DEVELOPMENT ASSESSMENT PANEL REPORT

Application No.	MOD/2023/0430
Address	35 Waterview Street BALMAIN NSW 2041
Proposal	Section 4.55(2) Modification of Development Consent DA/2021/0124, as last modified by MOD/2022/0247, which approved demolition of rear section of existing residence, refurbishment of existing brick building at front of site, and addition of three level rear extension. The subject modification application seeks the following: <ul style="list-style-type: none"> a. Permit a bi-fold fence/gate to the rear boundary fronting Jagers Lane spanning the width of the property. b. The addition of a privacy screen to the south-western end of the elevated ground floor rear terrace similar to that already approved on the north-eastern end of the terrace.
Date of Lodgement	15 December 2023
Applicant	Olo & Co Pty Ltd
Owner	Mr Huw L Davies Ms Iona M Steinle
Number of Submissions	Sixteen (16)
Cost of works	\$500,000.00
Reason for determination at Planning Panel	<ul style="list-style-type: none"> • Amendment to condition imposed by Planning Panel • Number of submissions exceed Officer delegations

project			
proposed alterations + additions 35 Waterview Street, Balmain			
drawing			
plans: garden level + ground floor			
date	drawn by	scale	drawing number
18 March 2024	RRM	1:100	DA.MOD1.01C

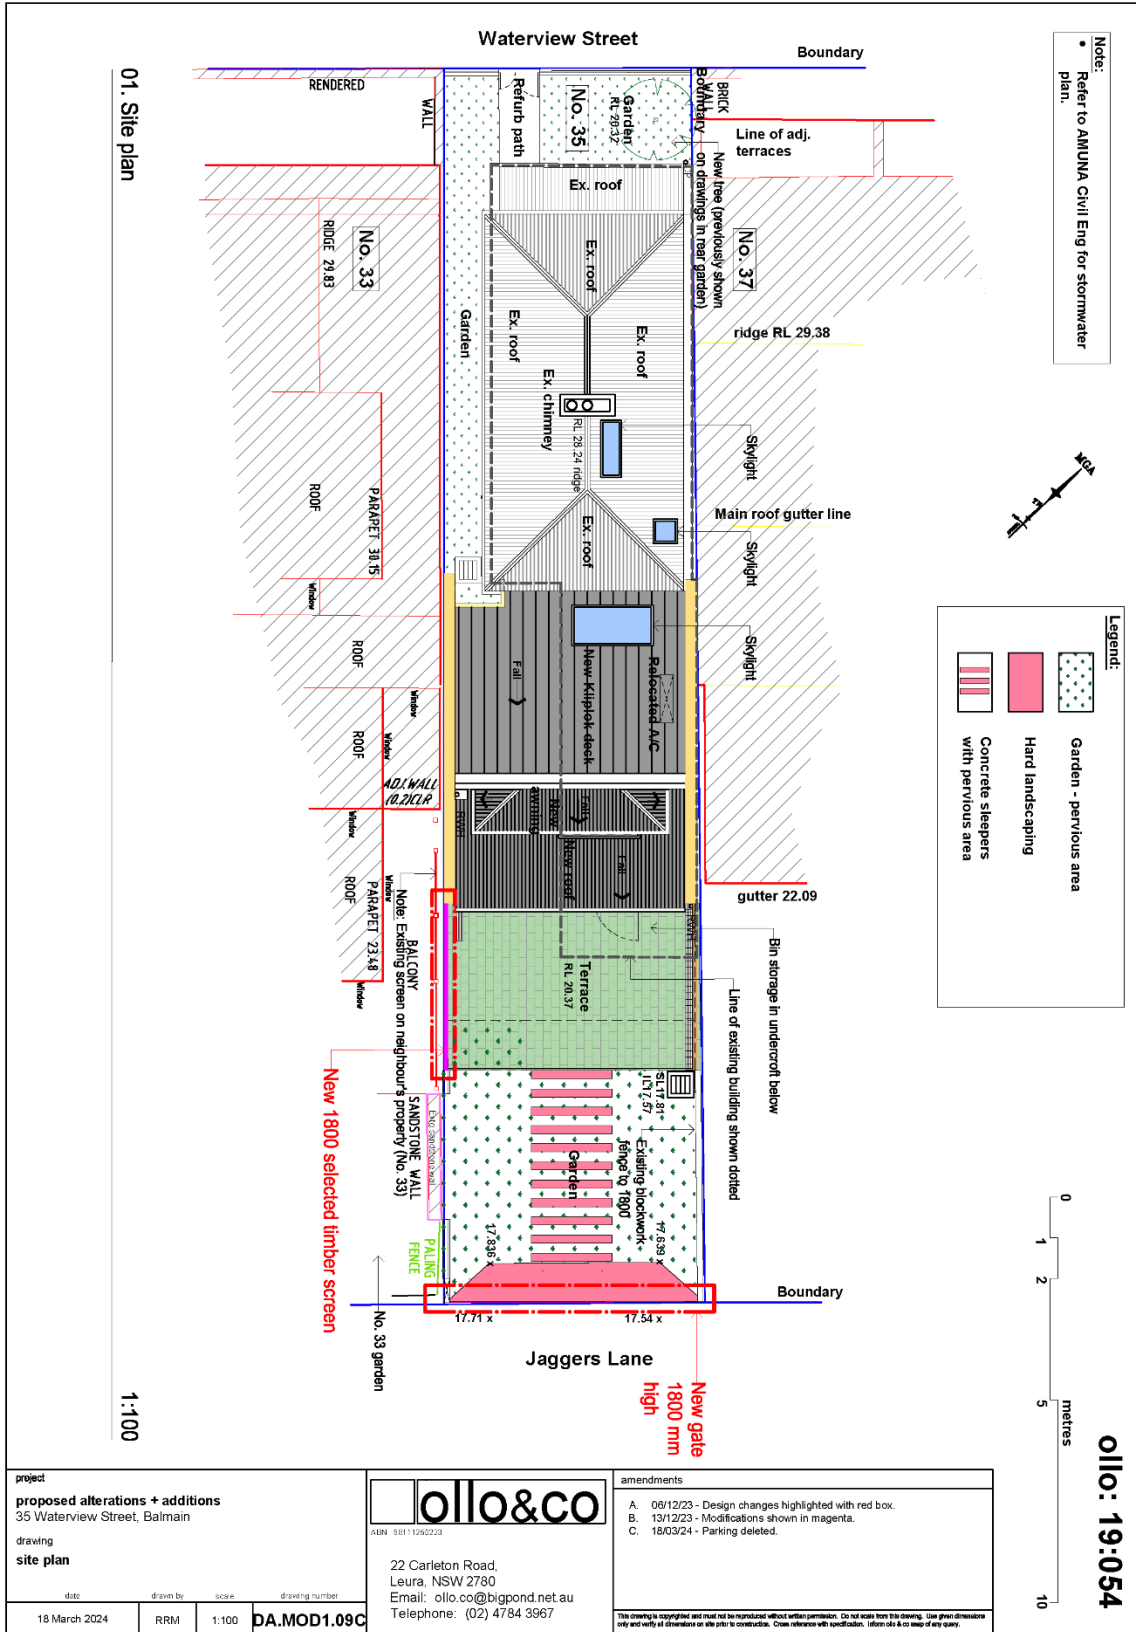
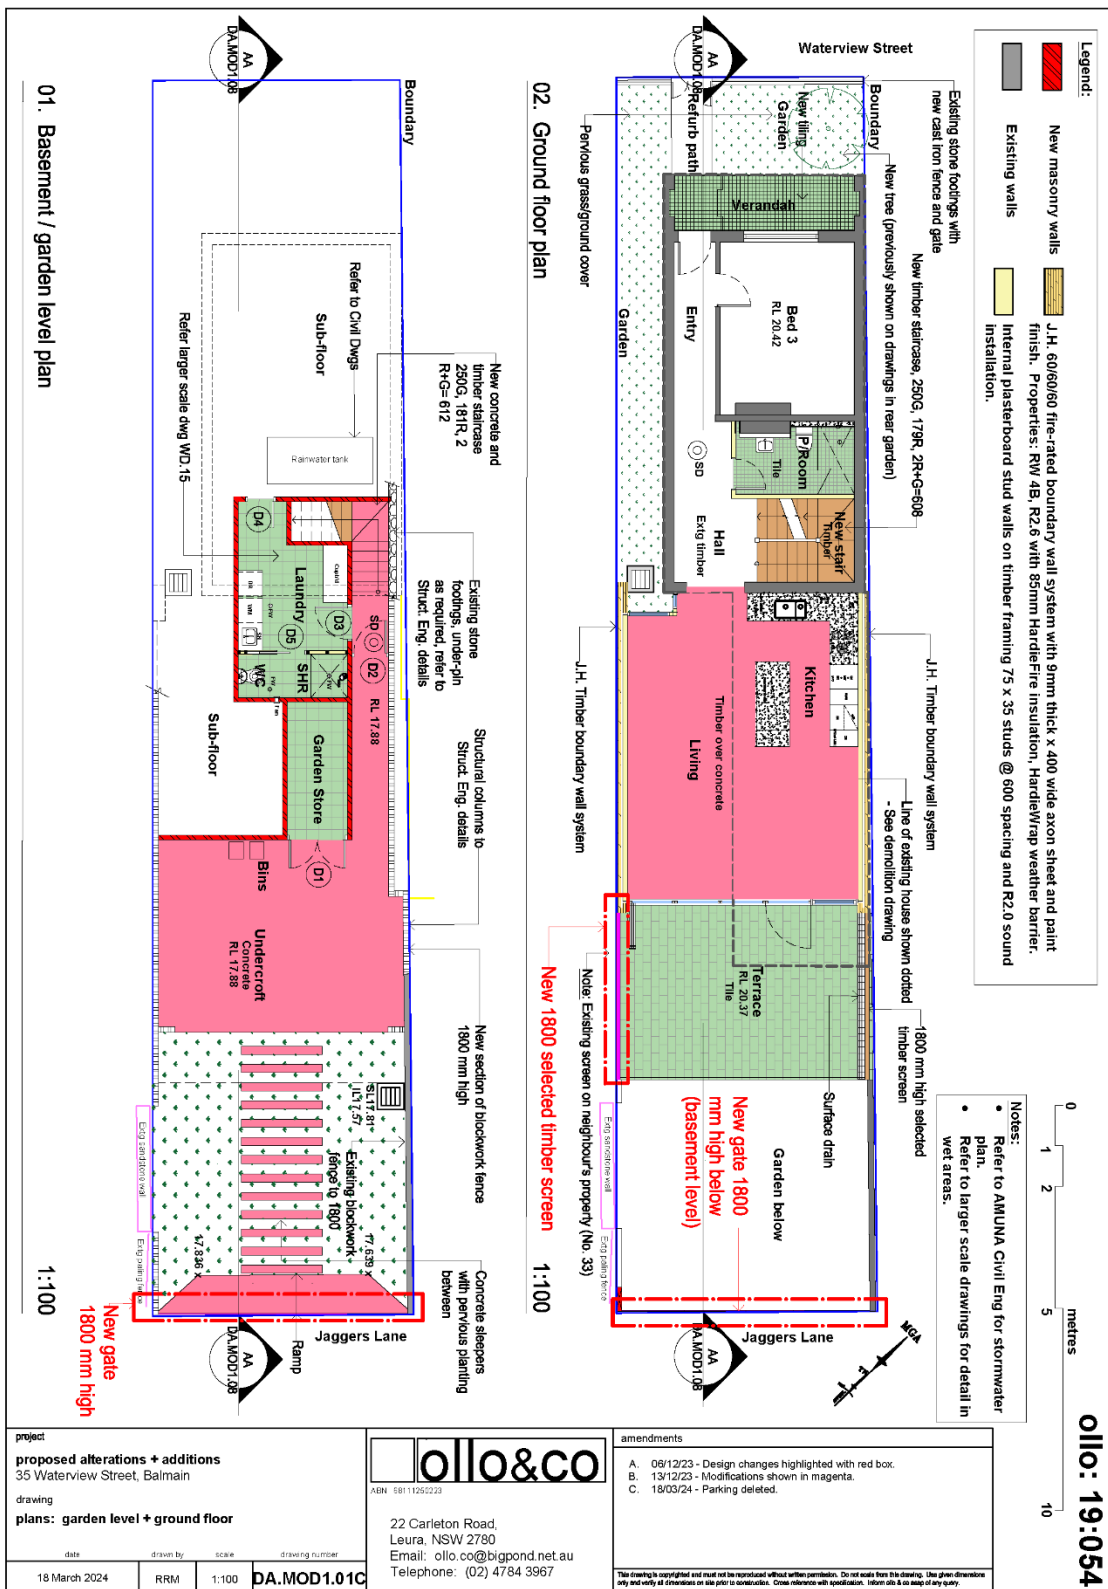
- a. The bifold fence / gate to the Jagers Lane boundary is not approved and is to be deleted. A timber fence and pedestrian gate to a height of 1.8m, with the pedestrian gate not exceeding a width of 1.5 metres, is to be provided to the Jagers Lane frontage.

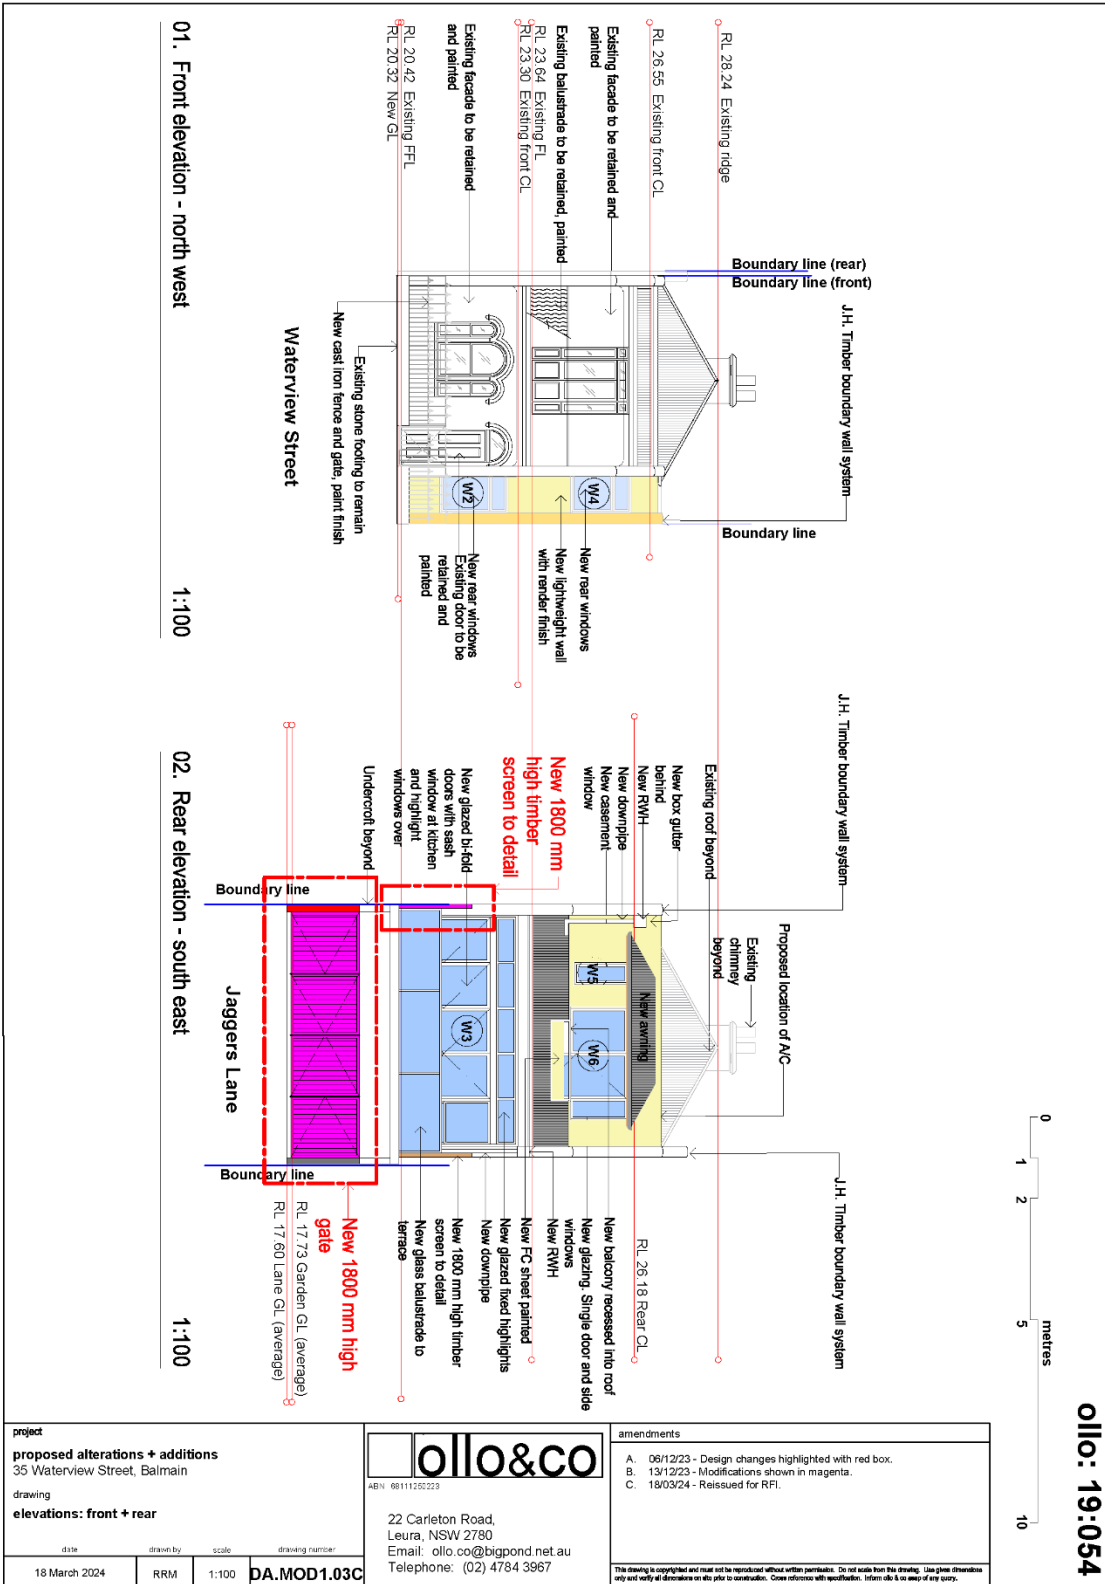
The bi-fold panelled access gate is of powder coated aluminium finish in a mid-grey colour with a height of 1.8m to the rear laneway known as Jaggery Lane. The access gate extends the entire width of the rear boundary.

Control	Proposed / Discussion	Compliance
C1.0 General Provisions	Subject to deletion of the proposed bi-fold fence/gate to the rear laneway frontage as conditioned, the proposal will comply with the relevant provisions and objectives of this part of the DCP.	Yes, as conditioned
C1.3 Alterations and Additions & C1.4 Heritage Conservation Areas and Heritage Items	The proposed alterations and additions to the dwelling house will not result in any unacceptable or adverse streetscape and heritage impacts and acceptable amenity impacts on adjoining properties. The internal changes proposed relate to the reconfiguration of internal spaces and thereby bear no external amenity impacts and are considered acceptable.	Yes
C1.11 Parking	The applicant has deleted parking from the amended proposal under assessment, however, seeks to provide bi-fold fence/gate to Jaggars Lane extending the full width of	See discussion
